5R110W

DELAYED FORWARD ENGAGEMENT/SHUDDER ON TAKE OFF

Figure 1

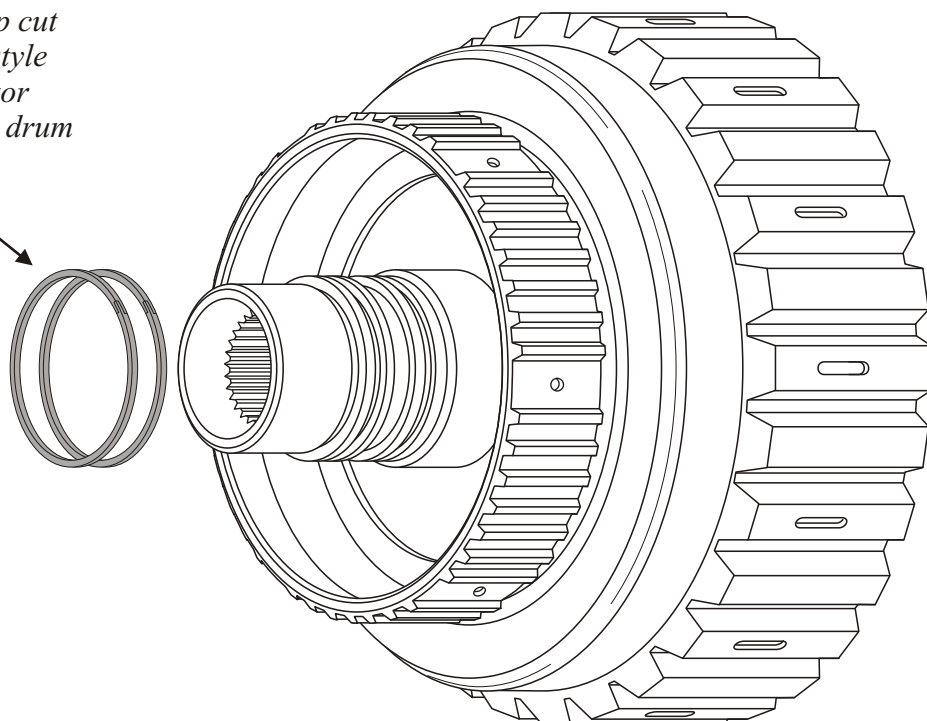
COMPLAINT: Before and/or after overhaul, a Ford truck equipped with a 5R110W transmission may exhibit a noticeable delayed forward engagement and/or chatter while in first gear at various throttle openings.

CAUSE: The cause may be a poor seal at the forward clutch sealing rings. (See figure 1)

CORRECTION: Check and verify that there are no line pressure and rise problems that may indicate a faulty pressure control solenoid, sticking PR valve, boost valve or faulty oil pump. Carefully inspect the forward clutch housing, piston and the seal ring area in the center support for any wear or damage and repair or replace as necessary. Place the completely assembled forward clutch housing into the center support and air check the forward clutch through the support to see if excessive leakage is revealed with the air check. If excessive leakage is detected, then the problem may be resolved by replacing the original step cut style sealing rings with a pair of solid endless style rings used for the stator support to reverse input clutch drum in a 4L60E transmission. The sizing tool for the 4L60E rings can also be used to ensure proper fit. After installing and sizing the new rings, check for a slight drag when installing the forward clutch housing into the center support and perform the air check again to see a noticeable difference.

Replace the original style step cut rings with the solid endless style rings used for a 4L60E stator support to reverse input clutch drum
